October 9, 2012

**RE: GEOTECHNICAL DESIGN REPORT, INTERIM GRADING PLAN, WHITE
POINT LANDSLIDE, W.O. E1907483, TASK ORDER SOLICITATION 11-087
SAN PEDRO DISTRICT, LOS ANGELES, CALIFORNIA**

Wagner provided the following interim grading plan (Plan) sheets on October 9, 2012:

WORK ORDER NO. E1907483
 DRAWING NO. C-2.0
 SHEET 3 OF 5 SHEETS

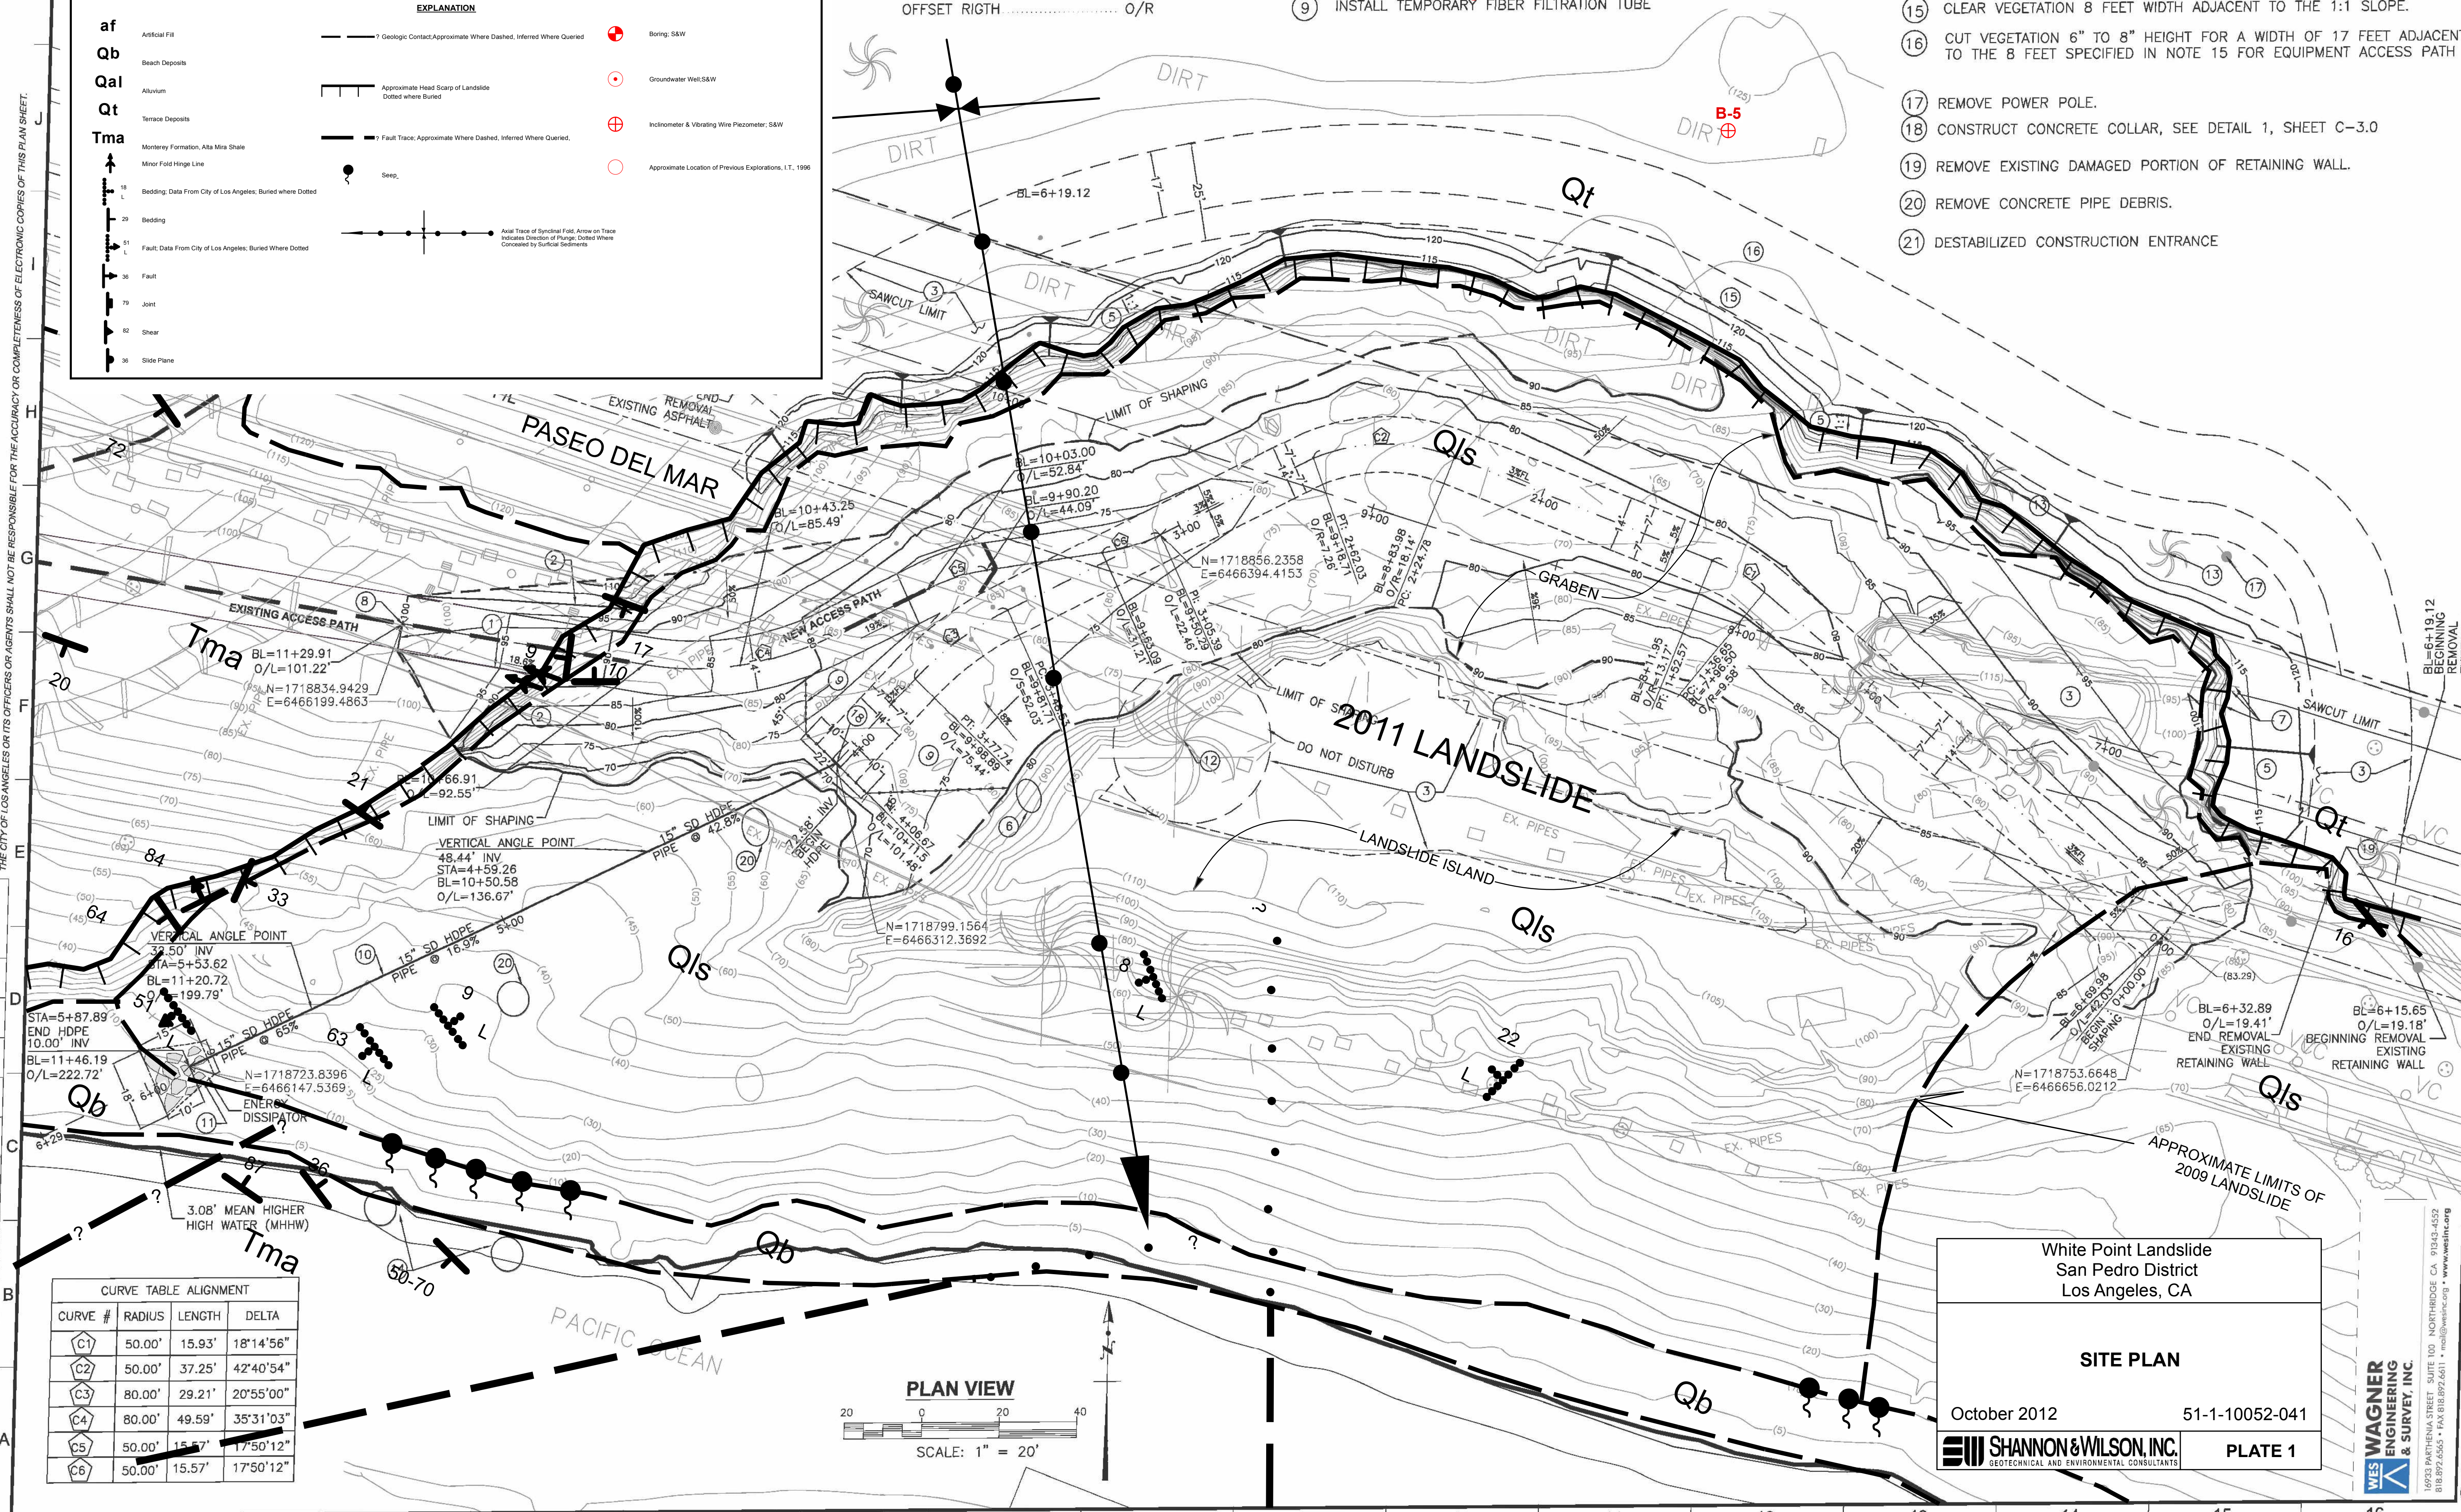
The following sections present our review of the Plan and construction recommendations for the proposed grading. The Plans have the following geotechnical-related construction elements:

Plan sheet C-2.0 and Plate 1 shows the proposed construction access road entering on the west side of the landslide from an existing access path. A temporary excavation through the scarp to access the graben includes cut slopes at 0.5Horizontal:1Vertical (0.5H:1V). Grading work should be avoided on the slope located south of the existing access road.

Re-sloping of the scarp should be completed from above the scarp if possible, to reduce the potential for unstable scarp material falling onto equipment or personnel. The scarp slope is proposed at 1H:1V. Where the scarp intersects Paseo del Mar, the existing asphalt paving will need to be cut and removed prior to grading. The vertical slopes adjacent to the scarp faces and within the landslide should not be considered stable where heavy equipment is immediately adjacent.

Fill consisting largely of landslide deposits will be needed for positive surface drainage in the graben as noted on the Plans. Because of potential stability issues with the “island,” we recommend spoils generated from the scarp excavation not be placed as fill within the graben. Wagner estimates approximately 1,100 cubic yards of spoils will be exported from the site.

The landslide deposits are suitable for fill material with the exceptions of bentonite and tar beds in the Altamira Shale fragments described previously. We do not anticipate significant quantities of these potentially unsuitable materials to be generated from the excavations. Heavy ripping may be needed when excavating the siliceous materials that could be present in the excavation, particularly at the access road. Where siliceous beds are encountered and cannot be readily broken down, we recommend they be removed from site, buried in deeper fill areas, or used as armoring/check dams for an energy dissipater. The fill materials should be placed in nominal 1-foot thick lifts and tracked into place with a dozer or other suitable heavy-equipment to adequately compact the material. Water should be applied to minimize dust during the grading operations. The graben area of the landslide should be leveled and graded at a minimum 2 percent gradient to drain to the sedimentation basin and pipe outlet per the Plans.

We recommend constructing a temporary drainage system installed at the west edge of the graben area to collect surface water runoff and direct it to a discharge point with an energy dissipation system. The drainage system may consist of a sedimentation basin, catch basin inlet structure, and high-density polyethylene (HDPE) discharge pipe. The locations of these features are shown on the Plan.

The HDPE pipe should be placed on the existing ground surface. We recommend restraining the HDPE pipe to prevent the joints from opening up if ground movement occurs, and from the weight of the pipe and stormwater runoff. Because of the potential for ground movement, we recommend that the pipe not be buried. Restraints could consist of cables that parallel the HDPE pipe with pipe clamps below each joint. The cables should be attached to anchors above the inlet that have sufficient capacity for the anticipated loads along the HDPE pipe. The drain pipe should consist of 15-inch diameter PVC or HDPE piping and should be installed in accordance with the manufacturer's specifications. A minimum 2 percent gradient should be maintained in the drain pipes. All drains should be surveyed by the Project Engineer to establish line and grade during grading, and for future location reference.
